Coroners (Investigations) Regulations 2013 – Regulation 28 Mr Warren Michael Myers, Deceased

DURHAM COUNTY COUNCIL (REGENERATION & ECONOMIC DEVELOPMENT) STRATEGIC TRAFFIC MANAGEMENT SITE INVESTIGATION FOLLOWING FATAL ROAD ACCIDENT REPORT M/T/S16/16

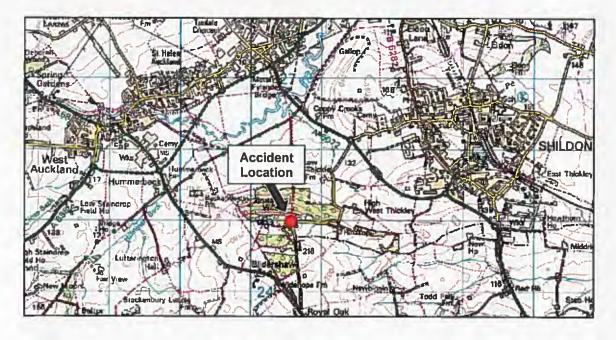
The 'Horses in the road' warning signs are in reasonable condition, however, the 'Bend ahead' warning signs are both in poor condition and appear faded or damaged (as shown to the right). The size of these signs would also appear to be too small, based on the anticipated 85th percentile approach speeds to the bend.

- The aforementioned 'Bend ahead' warning signs appear too small for the approach speeds to the bend in both northbound and westbound directions.
- The existing chevron plate provided for westbound motorists (opposite direction of travel to Vehicle 1) has slipped down the posts and is now not clearly visible on approach – see photographs at the end of the report.
- The existing chevron plates to Diag. 515 include a yellow backing board provision to improve conspicuity, however, the yellow border appears to be

- Provide suitable 'Bend ahead' warning signs in-line with the 85th percentile speeds on approach to the bend in both directions of travel.
- The appropriately sized chevrons (including appropriate yellow backing) should be provided on the bend to benefit both directions of travel. Clear visibility of the signs should be provided.
- Due to the amount of kerb strikes, this bend may benefit from additional engineering measures to warn of the bend and reduce approach speeds in both directions of travel.
